BEAUTY SUITES

2001 NY-17M (SOUTH ST.)
GOSHEN, NEW YORK

PROPOSED FLOOR PLAN

DRAWING NUMBER SK-101

SECOND FLOOR PLAN

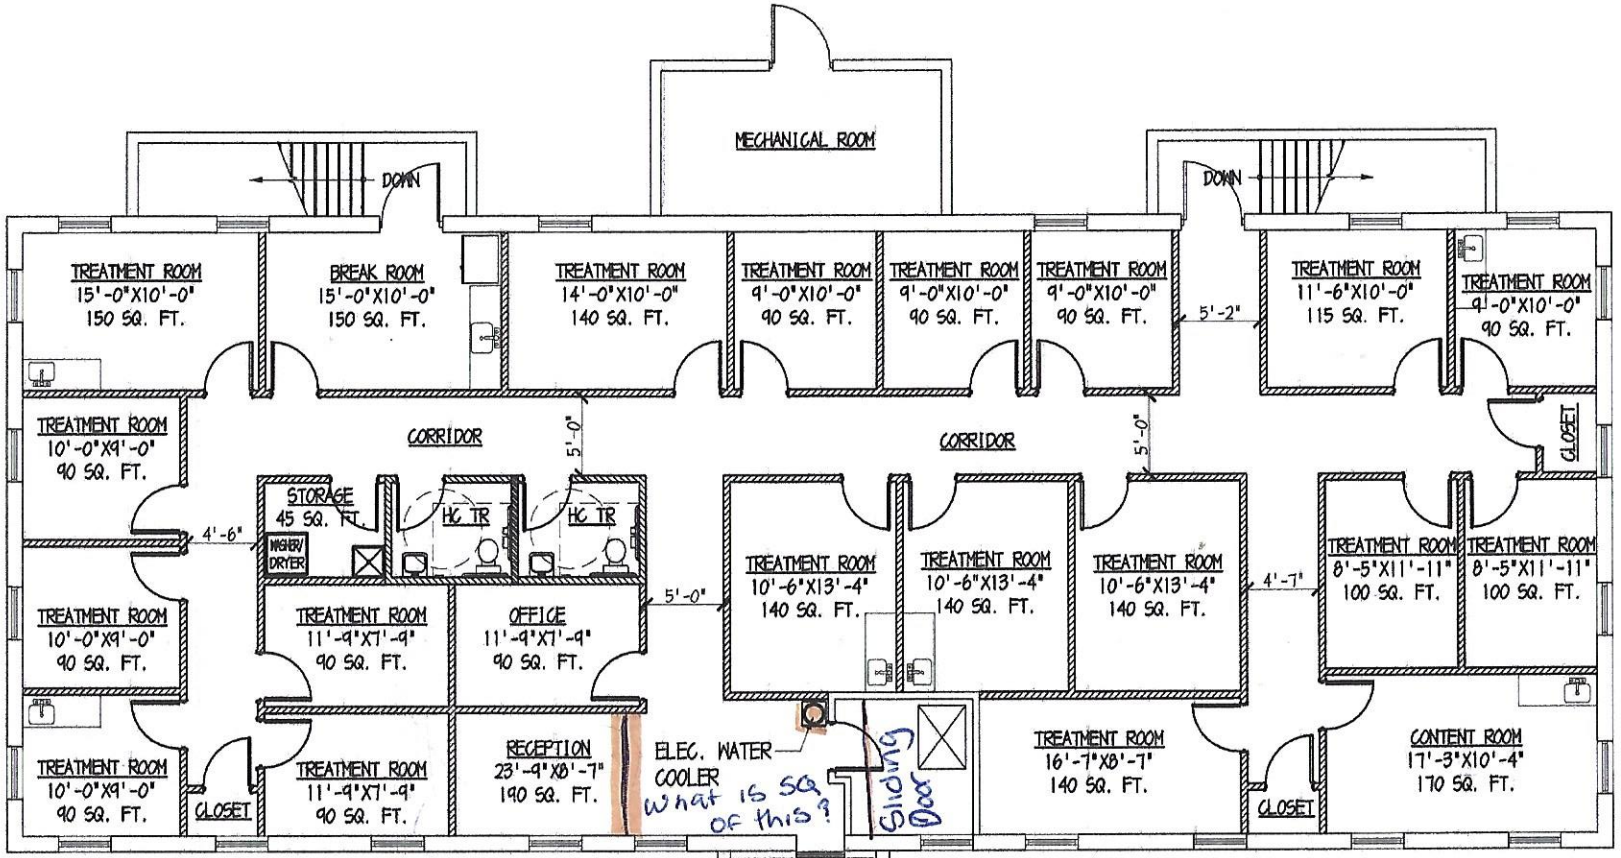
- Can we move cooler back to the breakroom?
- Can we put the treatment room back near recepton
- ~~Sliding glass doors or normal~~ glass doors on Rooms
- key fob access or password access
- Sliding door on elevator room to make room Smaller
- Half with sinks Half with plumbing for sink
